**City of West Linn
PRE-APPLICATION CONFERENCE MEETING
SUMMARY NOTES
October 21, 2010**

SUBJECT: Les Schwab at 19080 Willamette Drive

PRELIMINARY NOT FOR CONSTRUCTION
LES SCHWAB TIRE CENTERS LS Construction Co.

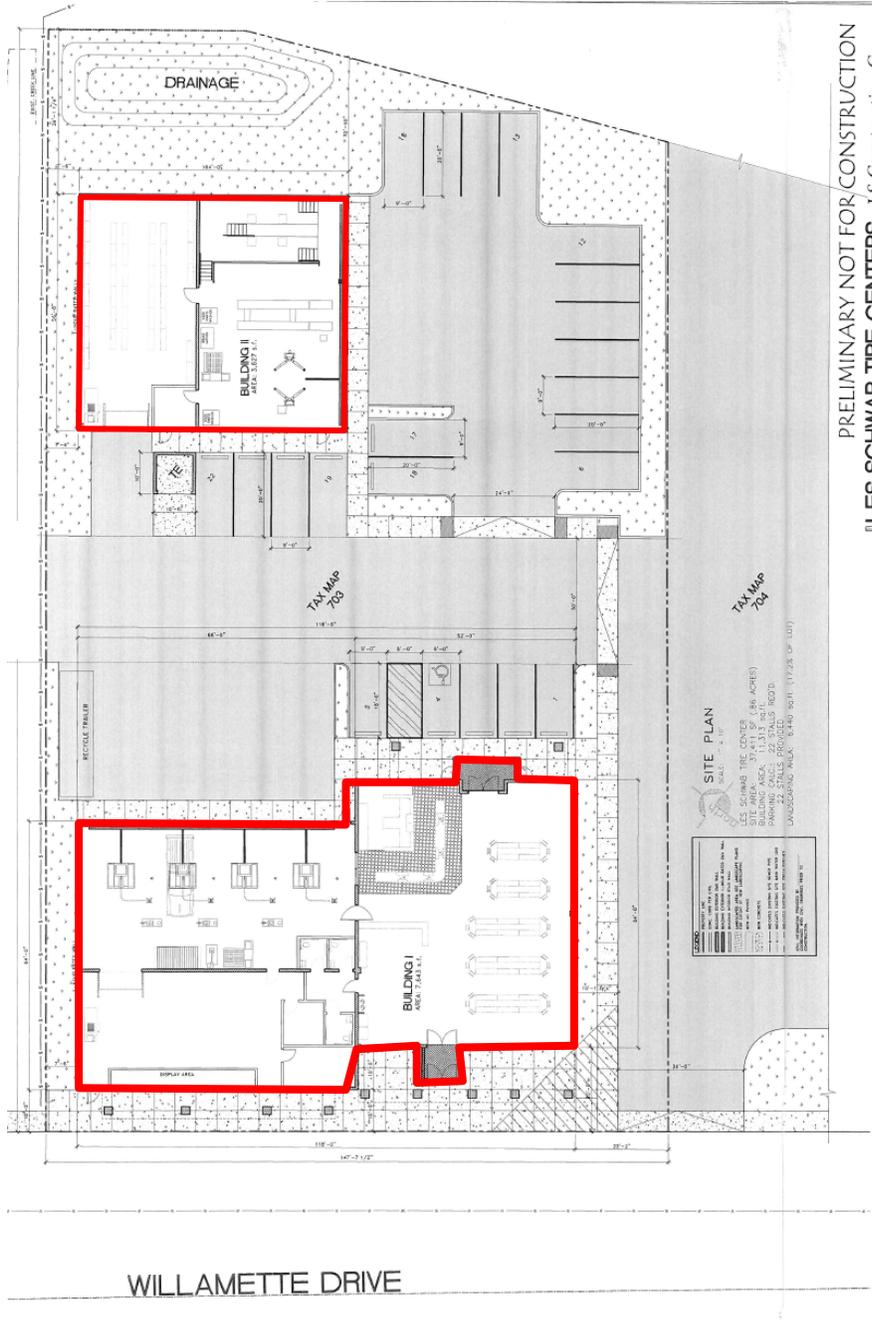
The site extends back or east 260 feet from the Willamette Drive ROW. The front two-thirds of the lot are flat. The land then drops down about 10 feet to a lower flat area at the rear of the existing Kasch’s building. The applicant will construct a retaining wall behind the rearmost building and parking lot then backfill/raise the grade in the lower/rear area to equal the grade in the front.

There are no drainageways, riparian zones, wetlands or other natural features as defined by the CDC on the property. The trees are few and limited to the rear property line. They appear to be three cottonwoods about 30-40 feet tall. These trees provide some screening between the site and the apartments to the rear of the site. (A survey is needed to determine if the trees are in fact on the applicant’s property.)

**Lower grade
at rear of
existing
building**

**Cottonwoods
screen
apartments to
the east**

NORTH ELEVATION

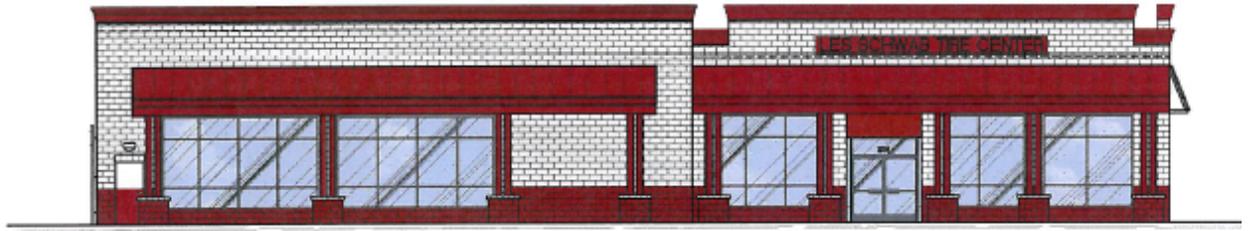
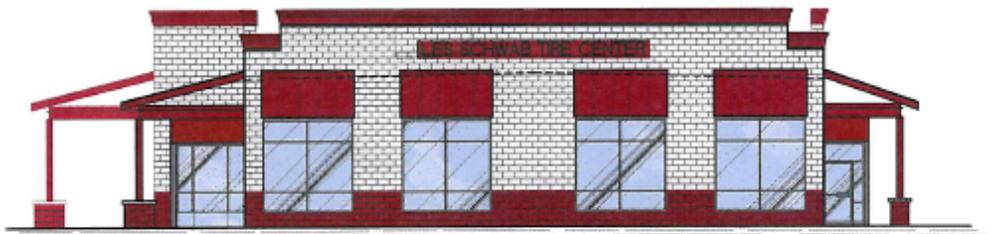
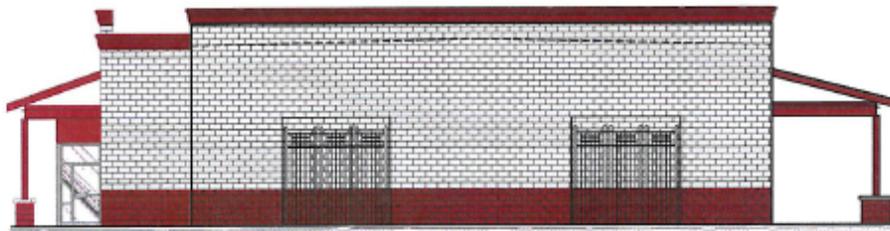
The design submitted by the applicant is a single story building clad in faux brick made of Concrete Masonry Unit (CMU) with a parapet wrapping around the upper edge of the roof. As seen from Willamette Drive the front elevation is broken into two, almost equal, parts with one set back ten feet behind the other. This breaks up the horizontal plane effectively and presents the opportunity to break the building's scale and mass down even further by using different building materials and different parapet heights on these two parts. The applicants explained a willingness to add horizontal bands of decorative brick work in the upper sections of the building. Staff would encourage the use of brick or other materials to contrast with the CMU.

Both staff and Tom Boes (RNA) wanted to see the awnings extend perpendicular from the face of the building rather than slope down at a 45 degree angle. The awnings should extend out 6-8 feet with 8 feet of vertical clearance. The awnings should also extend continuously across the entire front building elevation to provide meaningful protection from rain and sun. Please verify with Gail Curtis of ODOT (gail.e.curtis@odot.or.us) the ability to extend awnings/overhangs into the state ROW. (See also the attached letter from ODOT.)

CDC 55.100(B)(7) requires that all businesses have at least one main entry onto the street side. The front vestibule entrance to the sales area meets the criteria for an entryway on the main street but could be made bigger because it is rather small compared to the one on the rear elevation.

Architectural concerns include the need to meet transparency requirements of CDC 55.100(B)(6)(f). Sixty percent of the lineal frontage of the Willamette Drive elevation must have windows. The north and south facing elevations also need 30 percent transparency each. Glass must be clear and cannot be mirrored or smoked etc. The transparency problem of an earlier design has been solved by windows across most of the street elevation (the minimum amount is 60%). The north facing elevation, which would be seen by traffic heading south on Willamette Drive, is shown with no windows. This is a problem. The applicant provided two decorative trellises to break up that elevation. But the CDC requires 30 percent transparency on that elevation. It would be possible for the applicant to get credit for surplus transparency on other elevations. Alternately, the applicant could apply for a variance which staff could support so long as some kind of wall decoration like the dog club uses further up the street or a vegetative or “green screen” is used. The use of a fairly flat roofline unadorned by cornices was supported by staff.

Note: the drawings above do not show the proposed color scheme. South elevation faces Willamette Drive.

1. Color changes.
2. Meeting permitted noise standards.
3. Adequate transparency on north elevation (facing southbound Willamette Drive) or successfully applying for variance.
4. Flat awnings across front building elevation painted black or left natural metal
